ADDENDUM No 1: Changes and Revisions

ORANGE COUNTY BID No 367-OC5429

EFLAND COMMUNITY CENTER RENOVATIONS

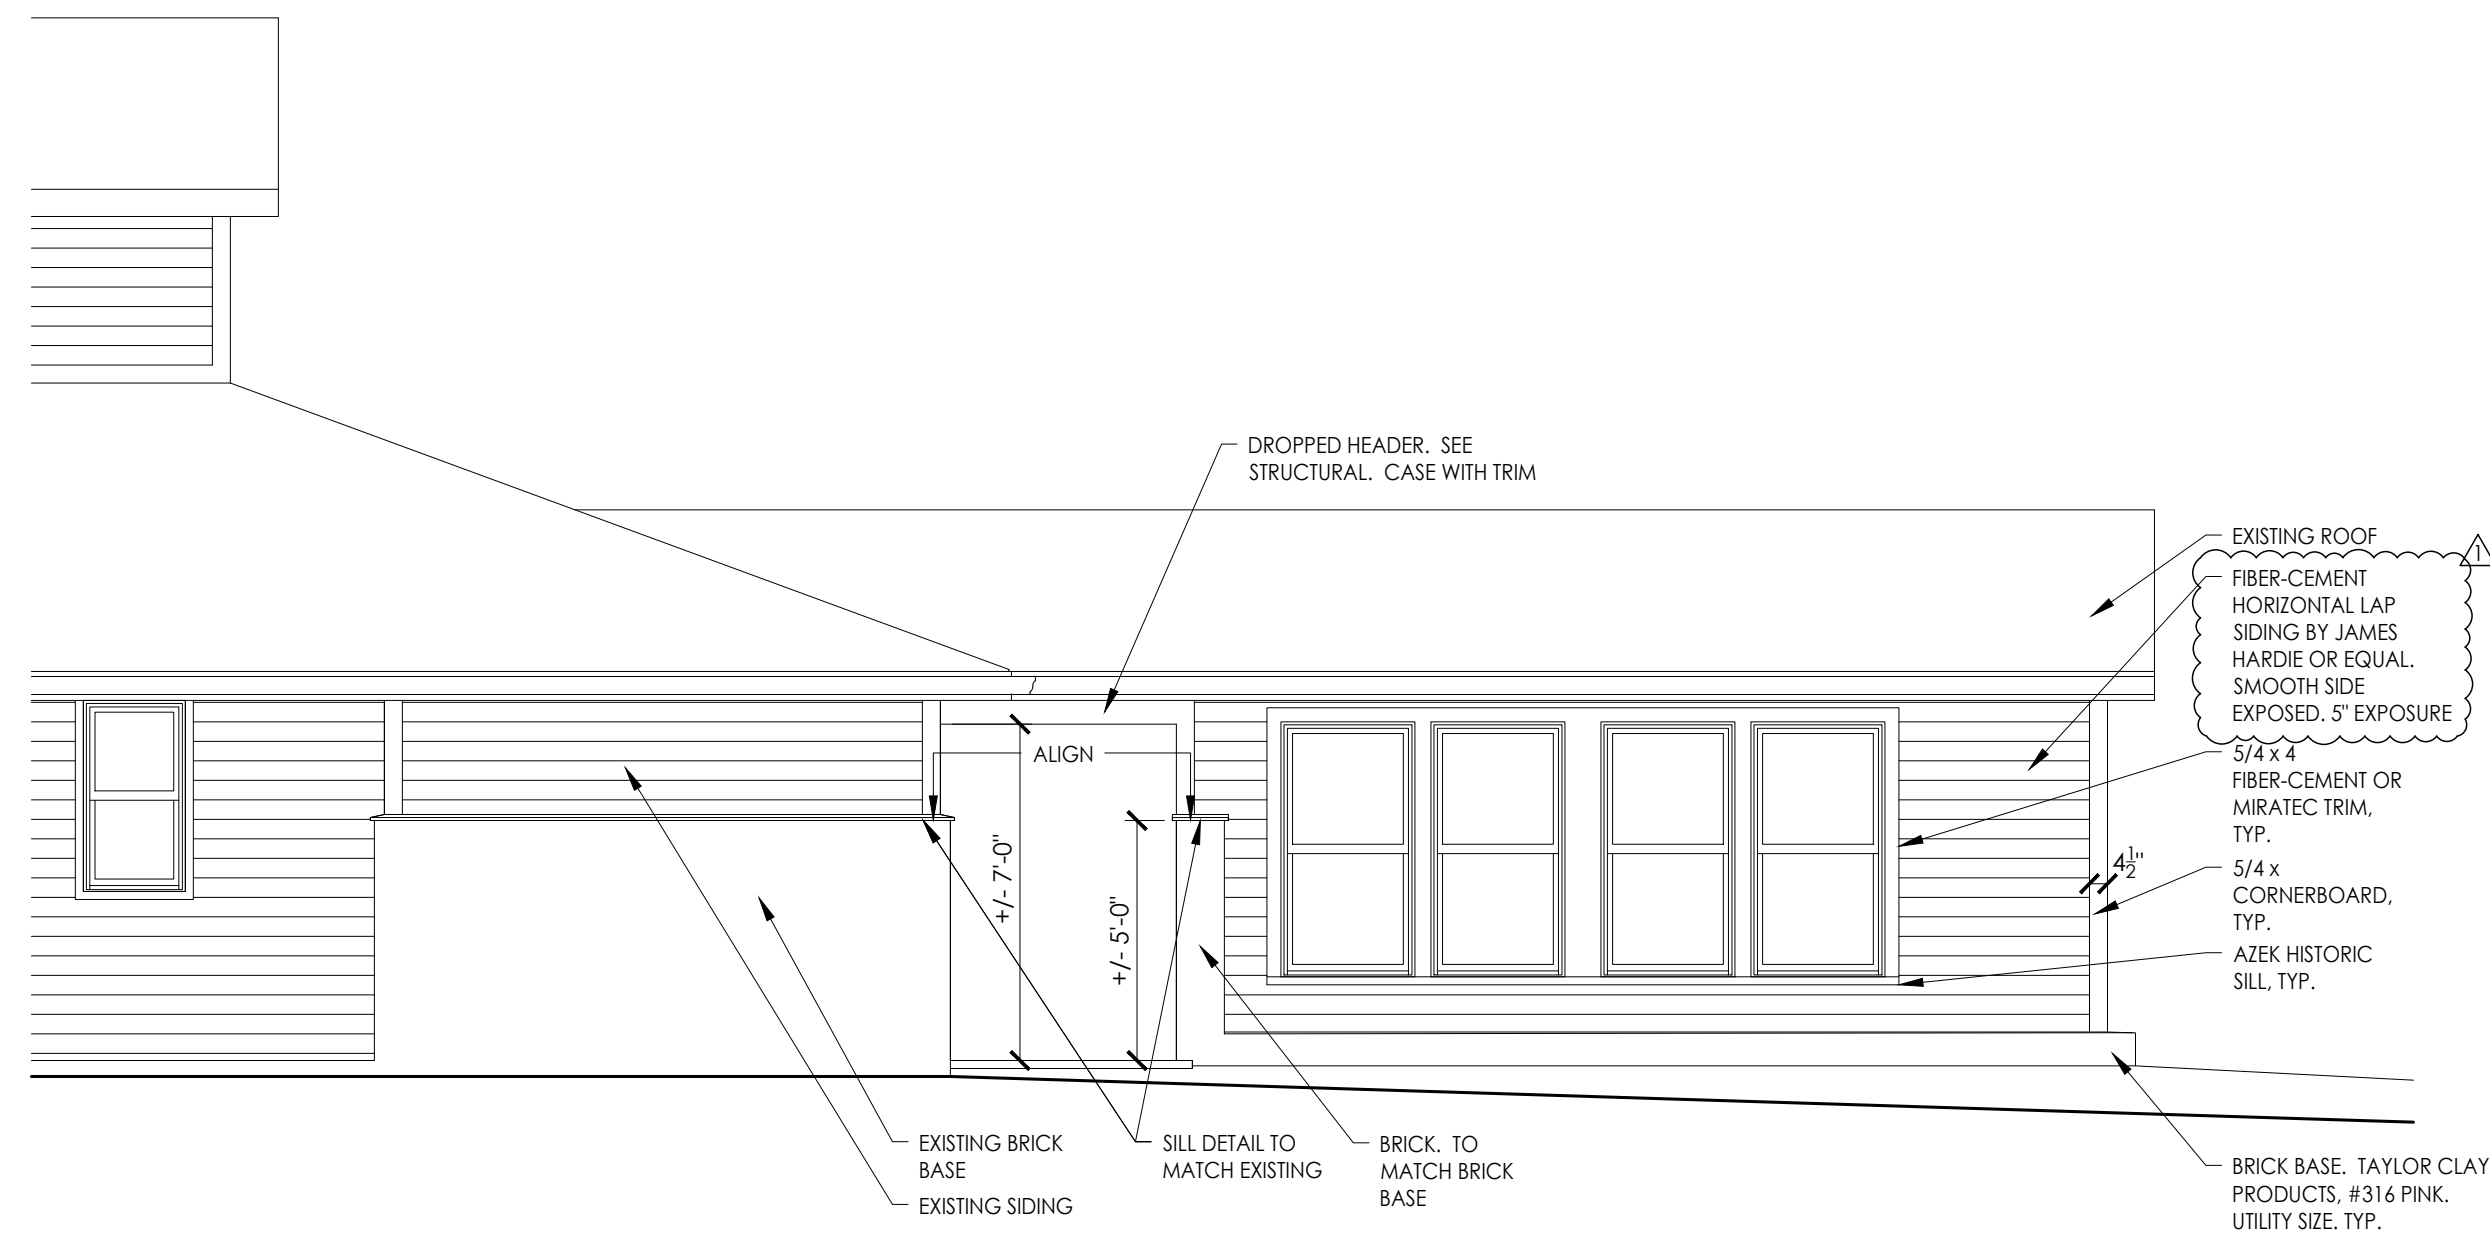
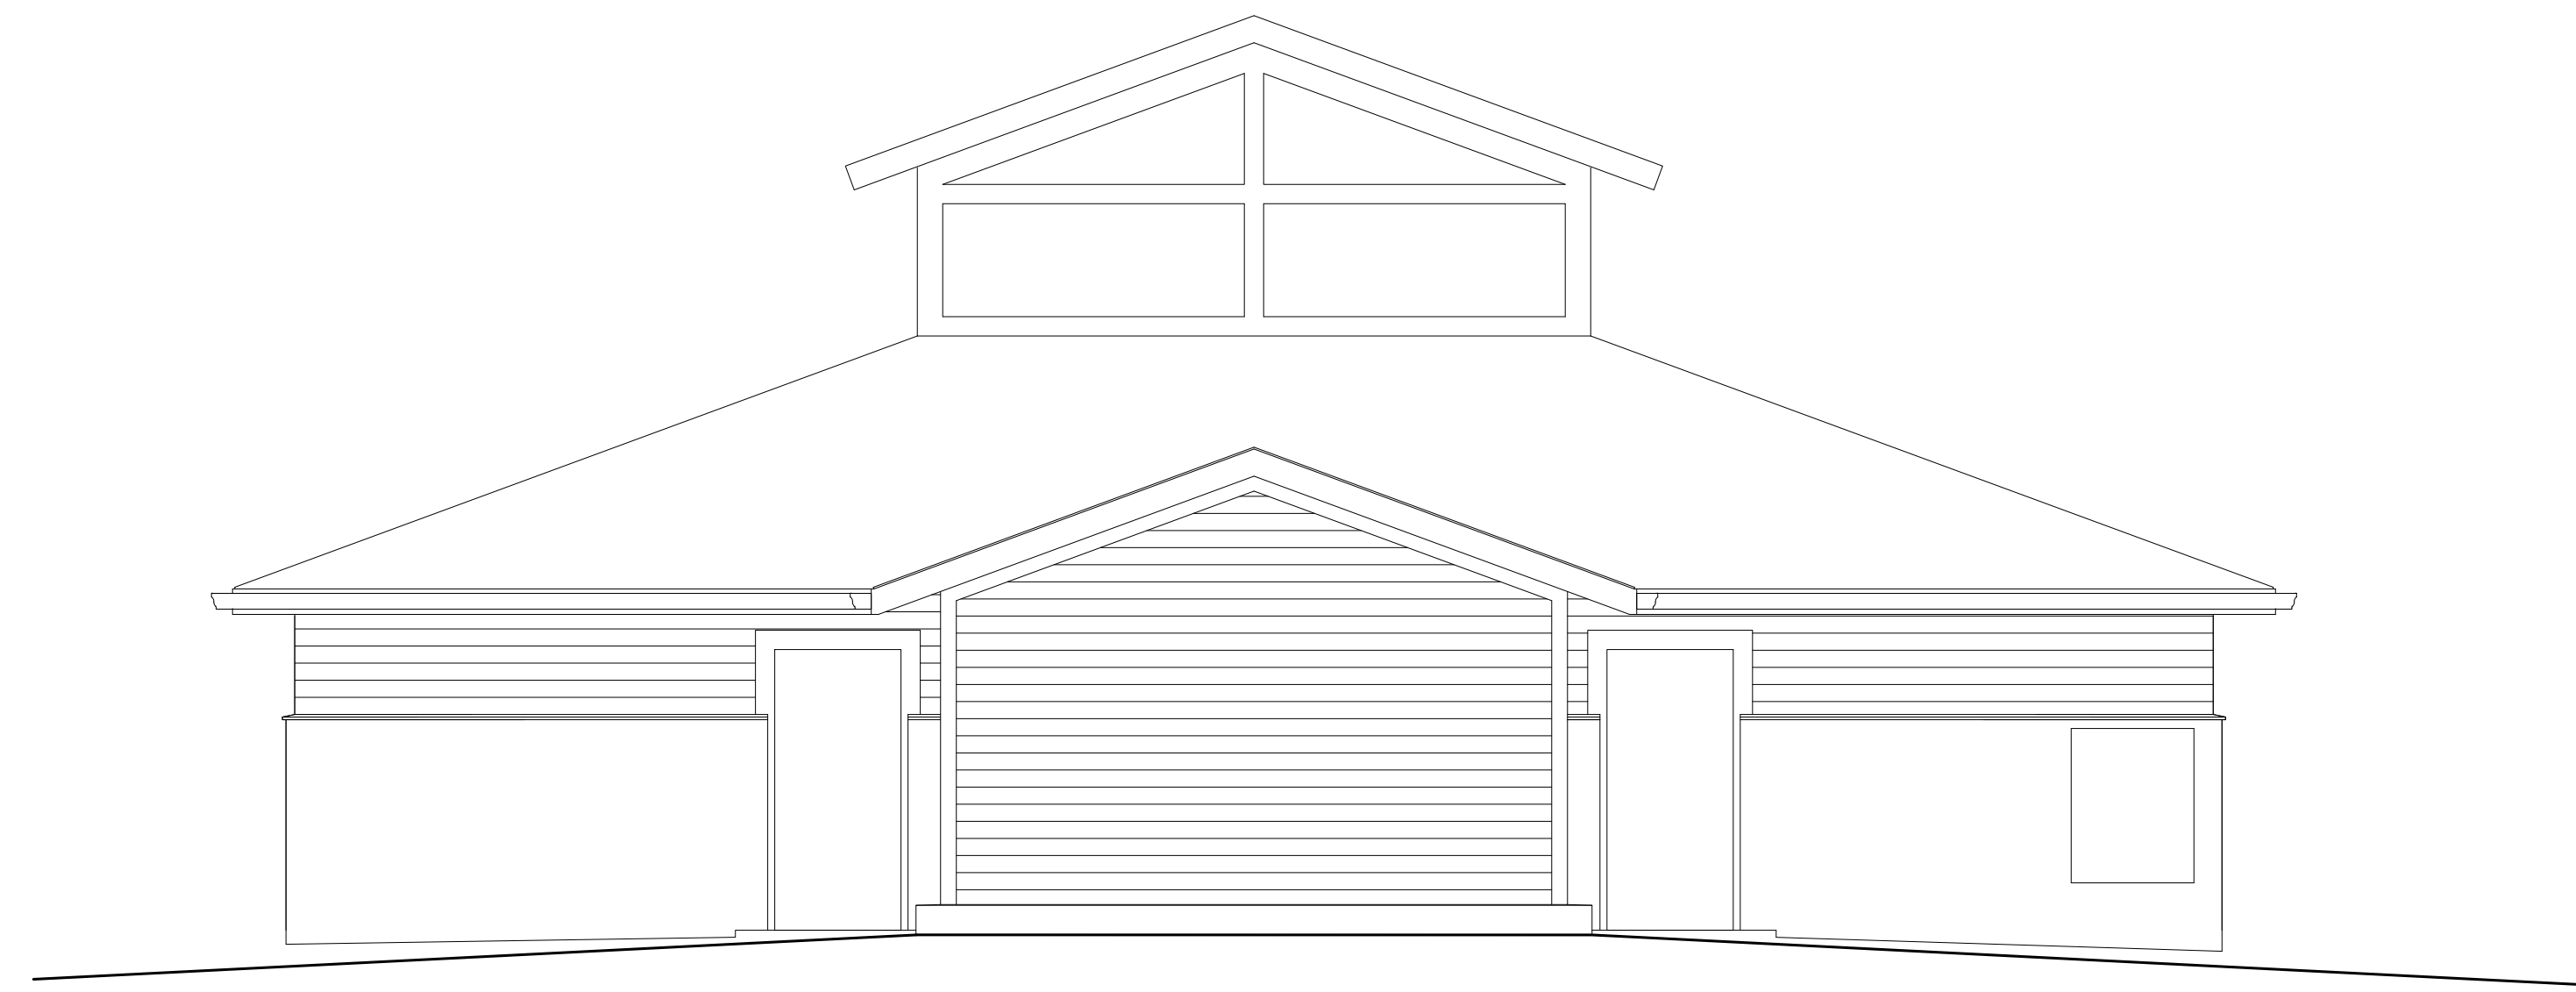
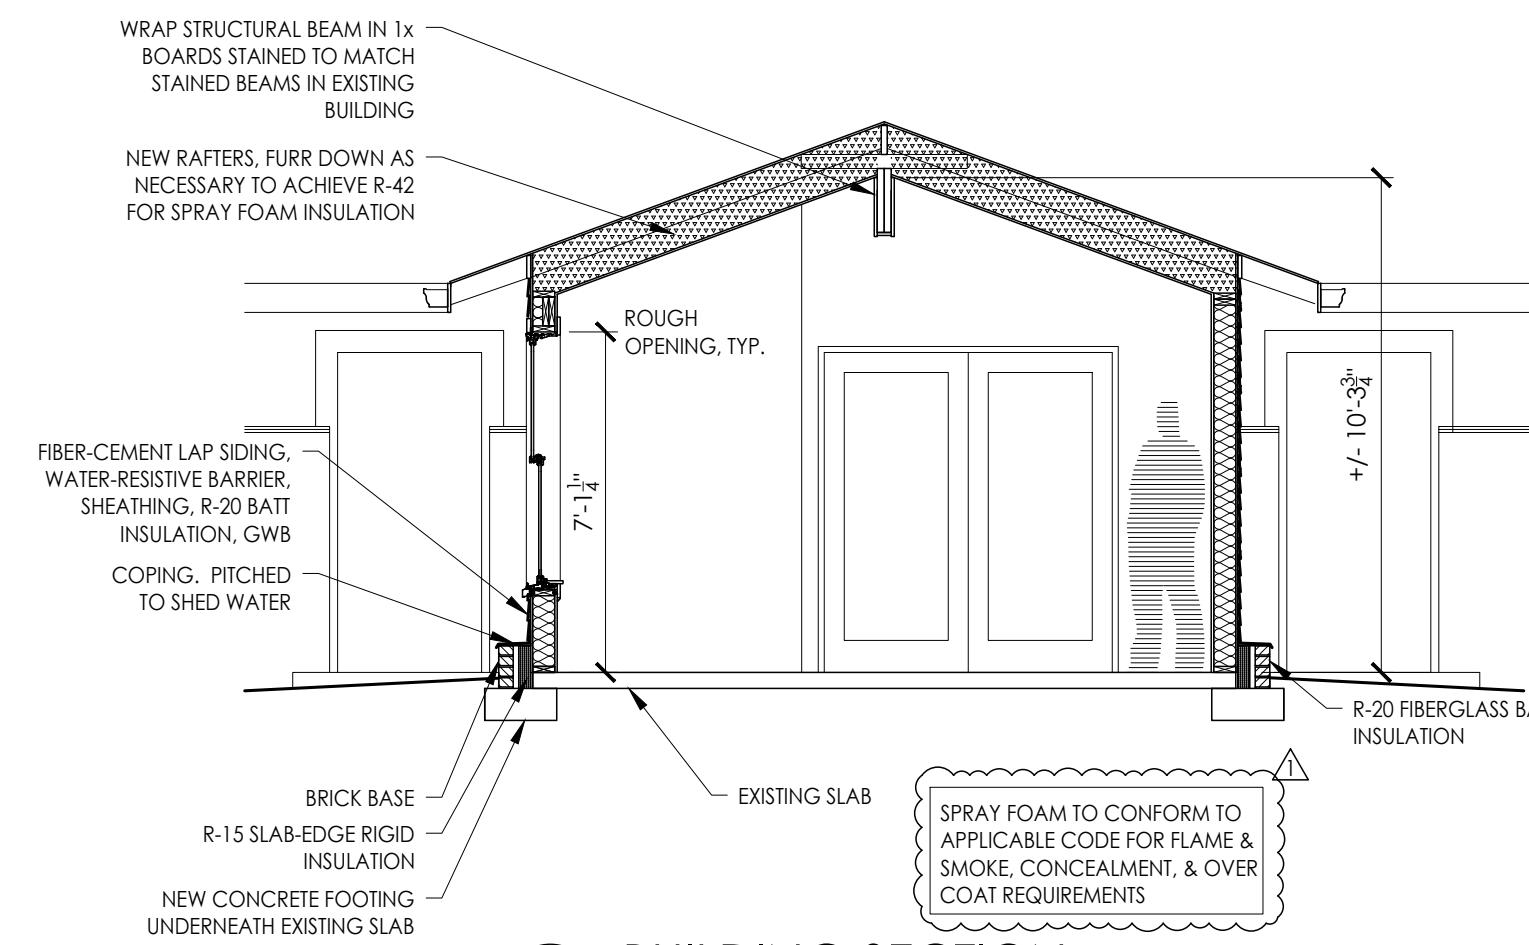
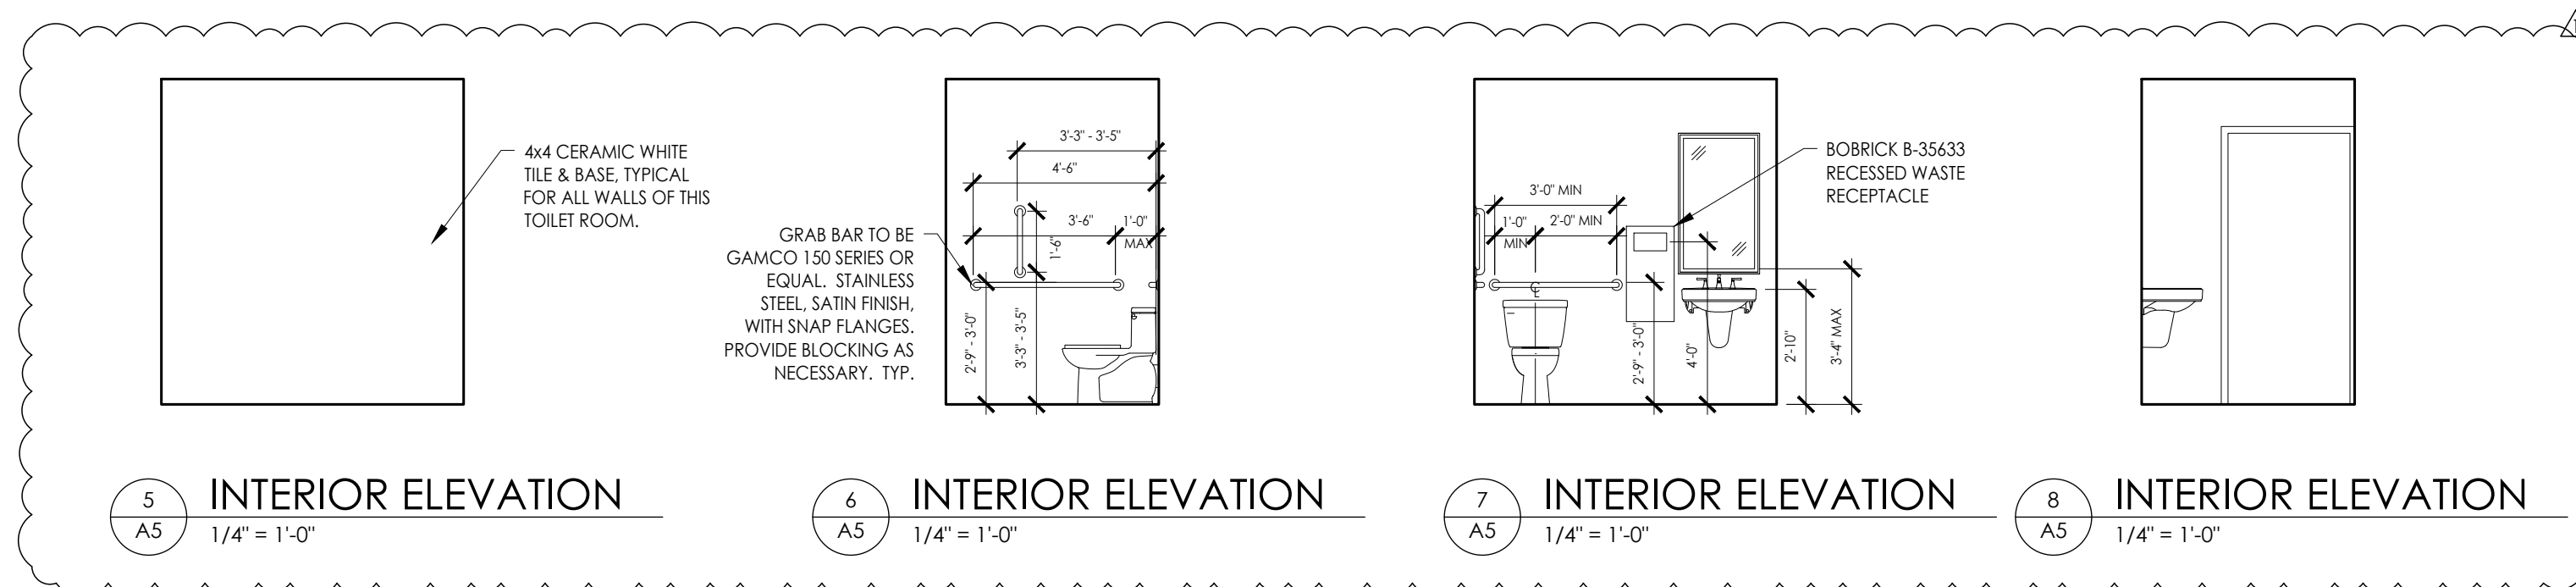
- *Sheet A5 has been revised to show updated interior elevations, an update to the note regarding exterior siding, and a new note regarding spray foam insulation.
